3 December 2012

SSI - 5414 - North West Rail Link EIS 2

FIGURE 1 – POTENTIAL APPROACH ROUTES

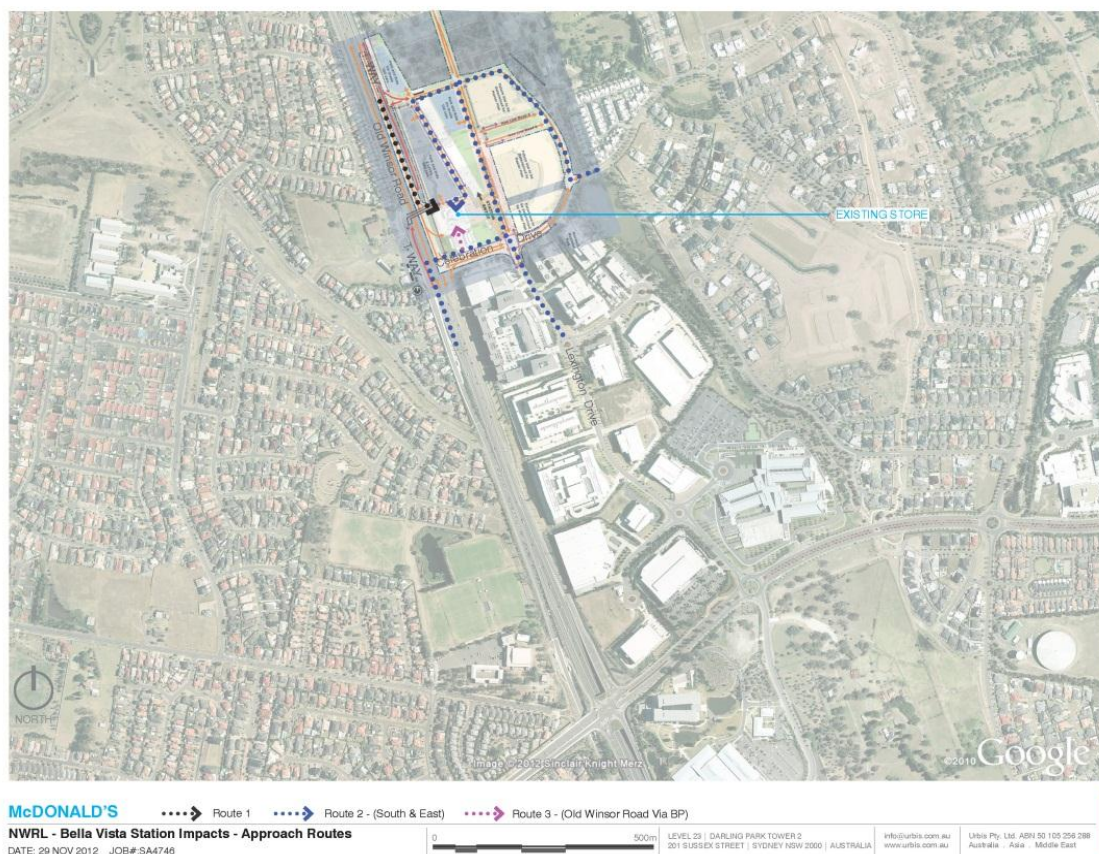
Figures 1 and 2 below illustrate the practical impact of entry and exit to the McDonald's outlet from the proposed layout for the Bella Vista Station precinct. Whilst the new slip lane entry into the site from Old Windsor Road is acknowledged, this must be balanced against:

- The practical ability for this slip lane to be constructed due to the alignment of the existing T-Way underpass; and

- It's effectiveness for McDonald's given that it is also providing primary access to an adjoining 800 car space park and ride facility. There is no detailed modelling or analysis within EIS 2 that give McDonald's any comfort that this is practical given the close proximity (circa 30m) that separates the entry to Park and Ride and entrance to the reinstated McDonald's car park.
- The circuitous route that trade originating from the residential area to the east must traverse as compared to the existing situation via Brighton Drive/Celebration Drive.

FIGURE 2 – POTENTIAL EGRESS ROUTES

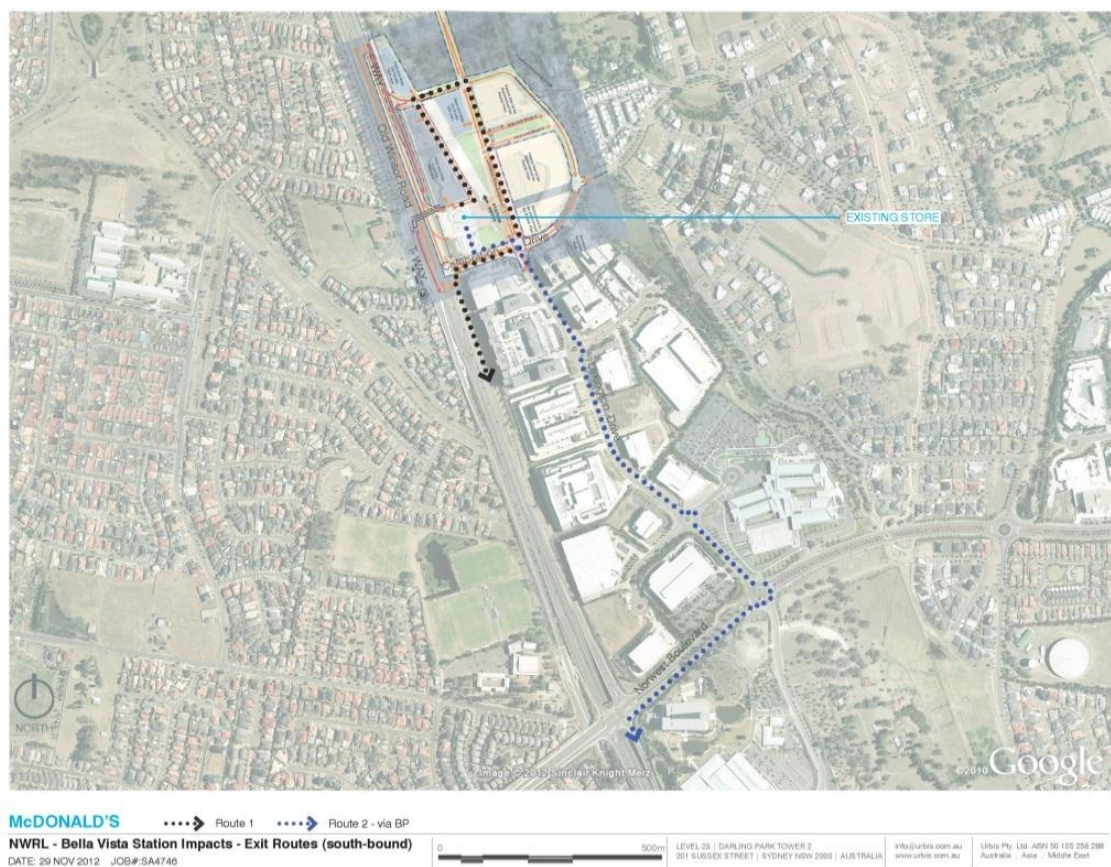
In contrast the proposed exit from the site is unacceptable and quite simply hasn't been given any thought at all. The key business driver for a McDonald's store is convenience. This is reflected for example in drive through trade generating a significant proportion of McDonald's store turnover in a typical operation. As the name suggests a drive through must be

The existing site benefits greatly from these 3 factors listed above. Figure 2 demonstrates that the proposal for Bella Vista Station delivers a sub-optimal and vastly inferior outcome for exiting traffic from that currently enjoyed by McDonald's. This is further discussed in the CBHK advice attached to this submission.

FIGURE 3 – ALTERNATIVE WESTERN EGRESS

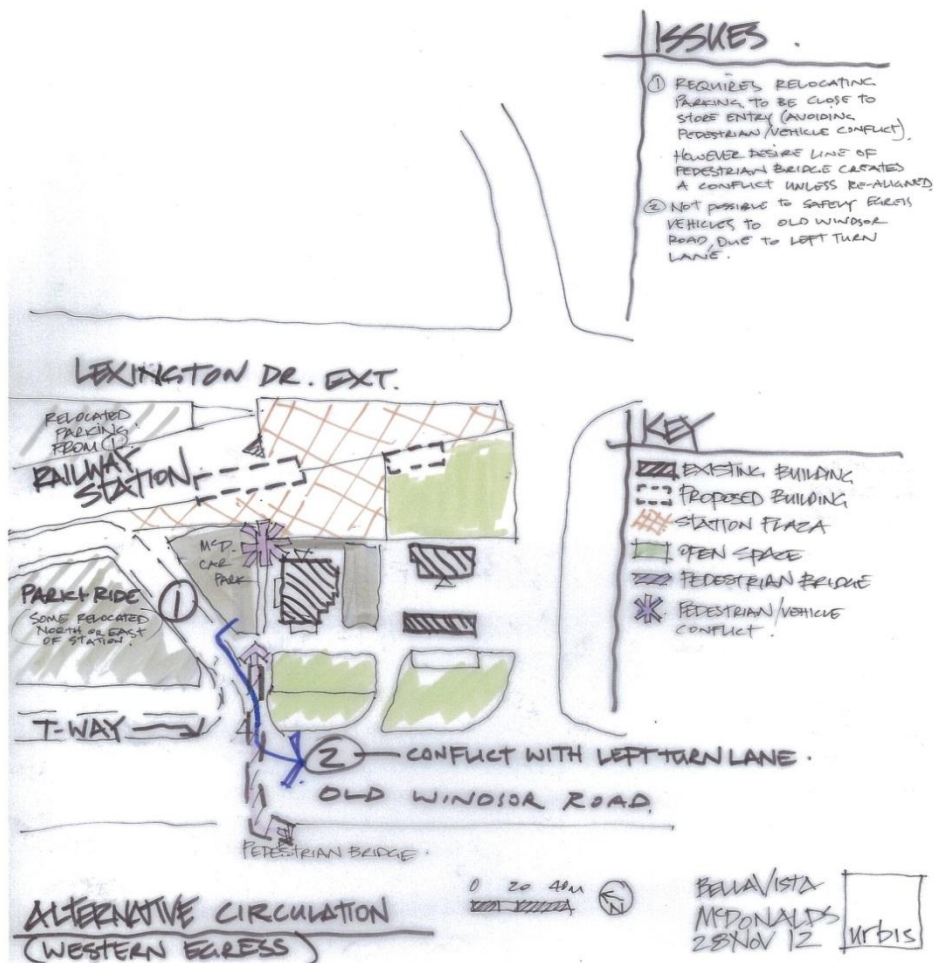
Unfortunately both options highlight significant constraints in achieving a comparable level of service from that currently enjoyed by McDonald's customers. Figure 3 includes as an option the realignment of the southern component of the park and ride facility which also enables a relocation of McDonald's car park which is considered to be a critical design consideration for McDonald's. This issue is discussed later in this submission. Figure 4 identifies 2 potential egress routes marked in red arrow "1" and blue arrow "2" which potentially go some way to addressing McDonald's issues, however both are not without their own issues which are documented on the drawings

FIGURE 6 – OPTION A

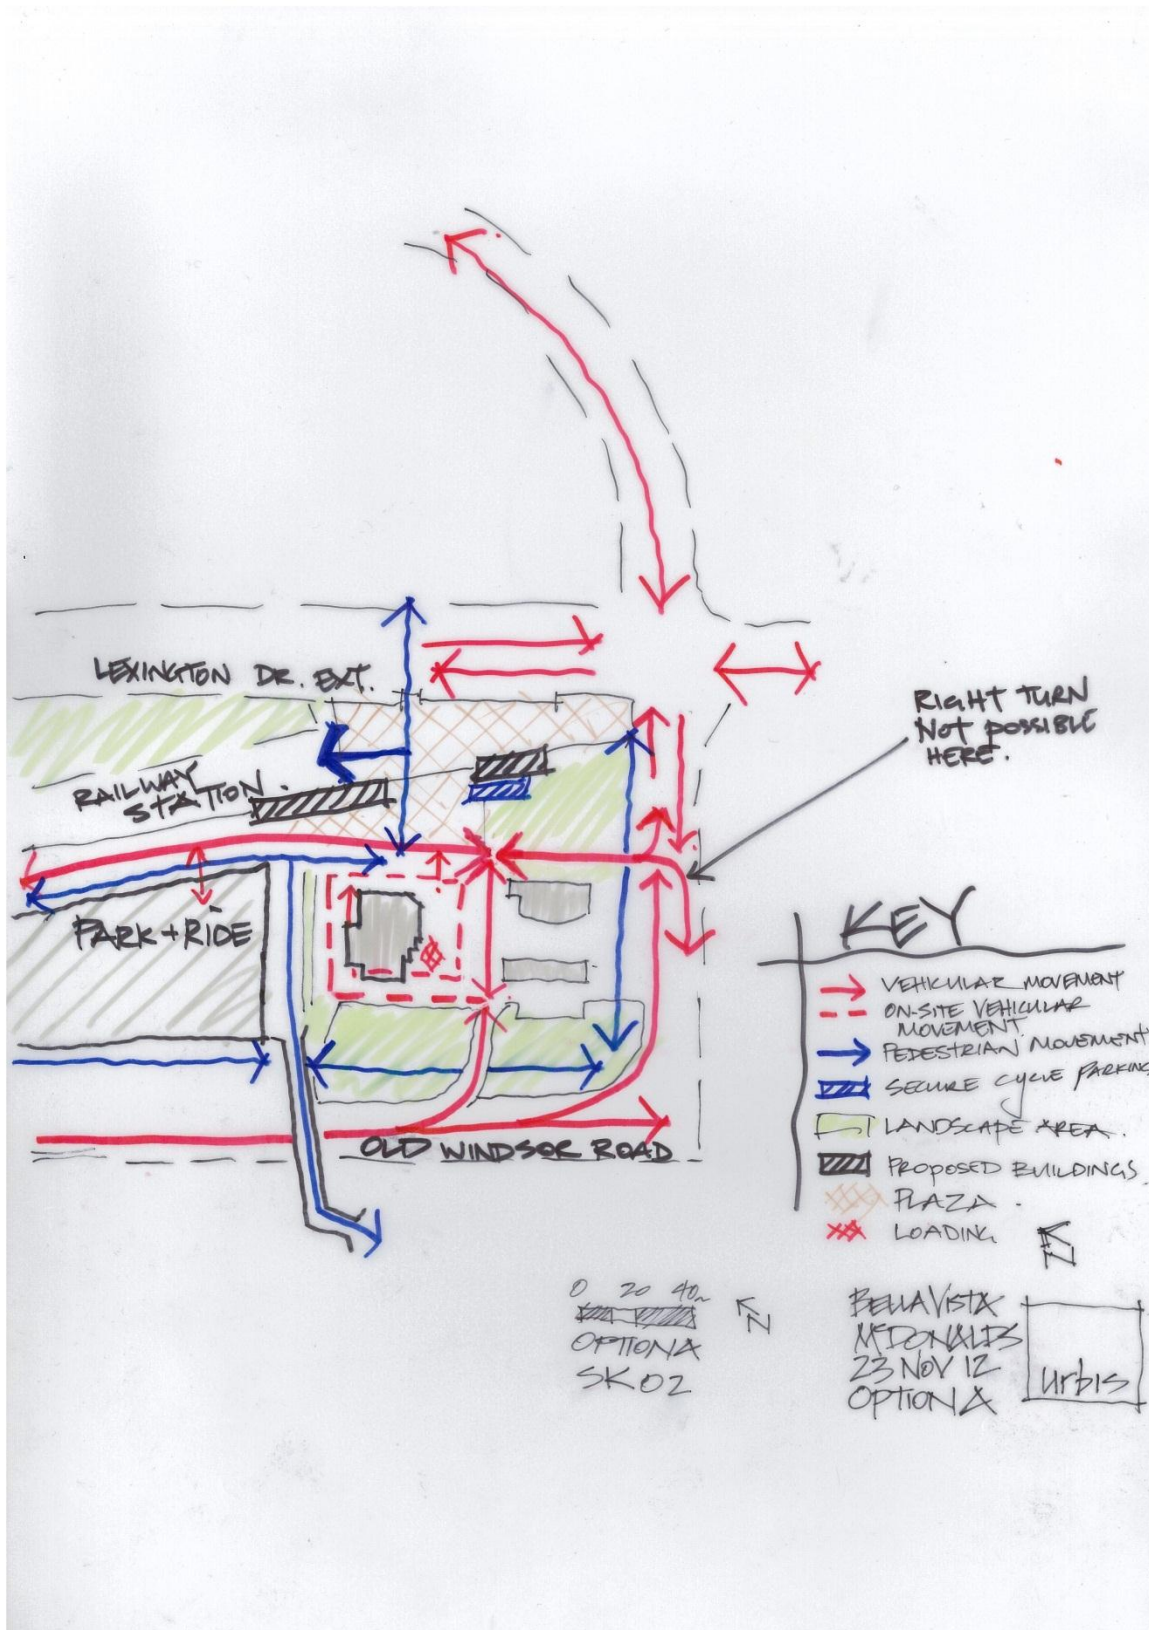
Whilst both options have to a degree demonstrated ability to achieve one or the other of the above, neither totally meets McDonald's design objectives. However and perhaps most tellingly:

- Neither option is capable of achieving the level of convenience currently enjoyed by McDonald's (and the adjoining BP) patrons in re-entering Old Windsor Road in continuing a south bound journey. This is simply because of the removal of the existing Lexington and Celebration Drive intersection round-about and the proposed installation signals. This feature alone not only means a more circuitous and less convenient means of re-entering the arterial road network, it also means that all McDonald's traffic will be diverted onto the local road network in the first instance when this is not currently the case. Similarly neither option can provides for the same the level of convenient access to and from the residential area to the east.

FIGURE 7 – OPTION B

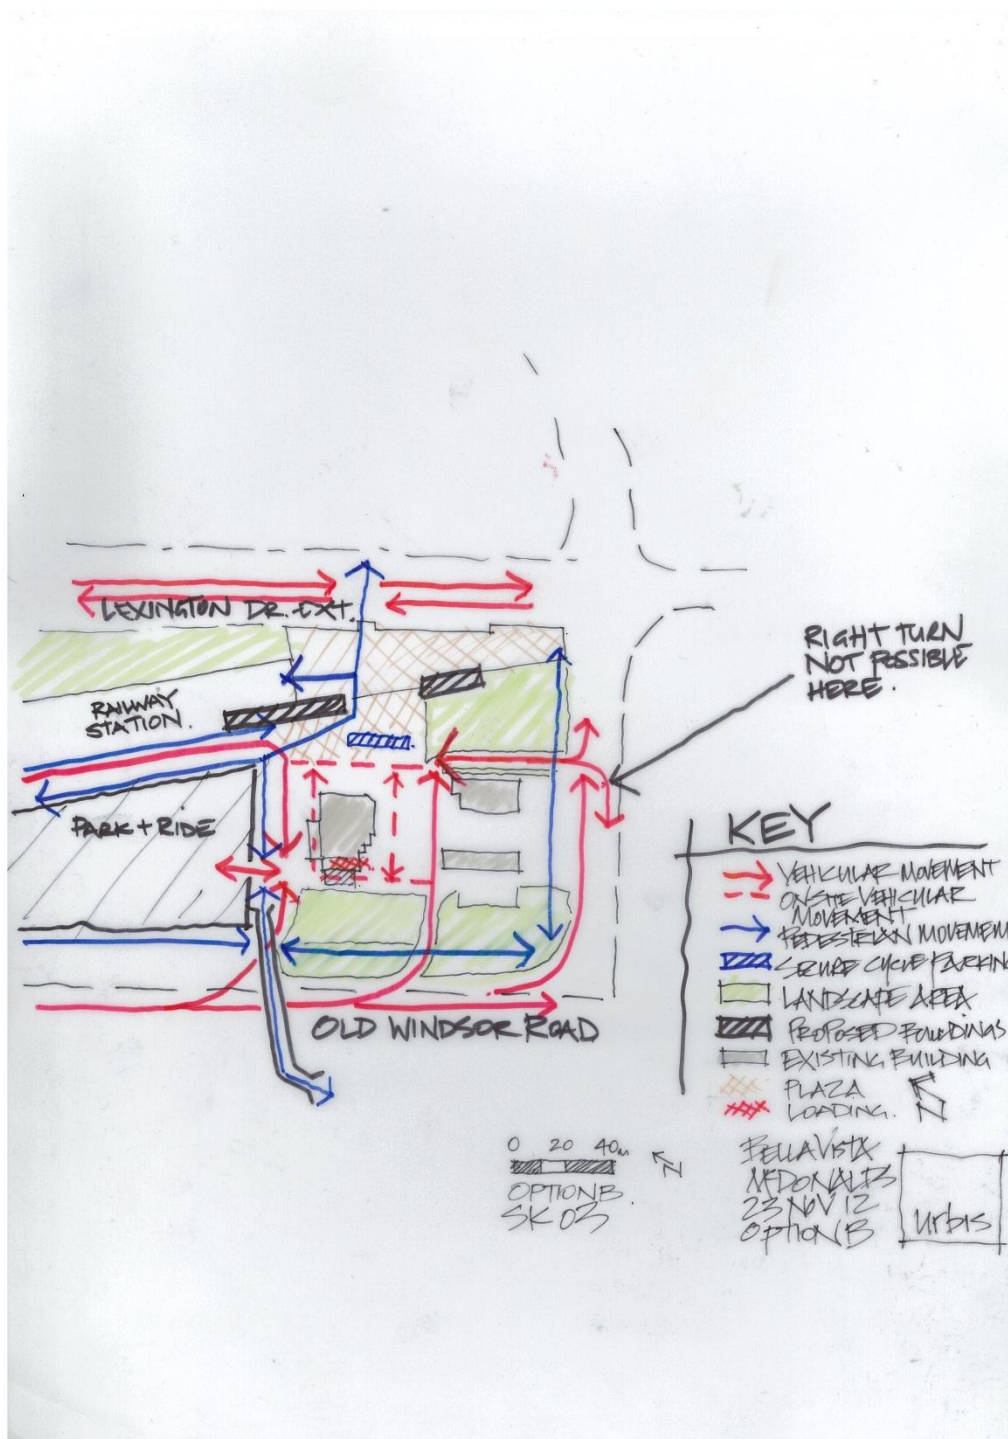
- Option B is not capable of providing for the same quantum of on-site car parking which is currently 43 spaces as required by the terms of McDonald's development consent.
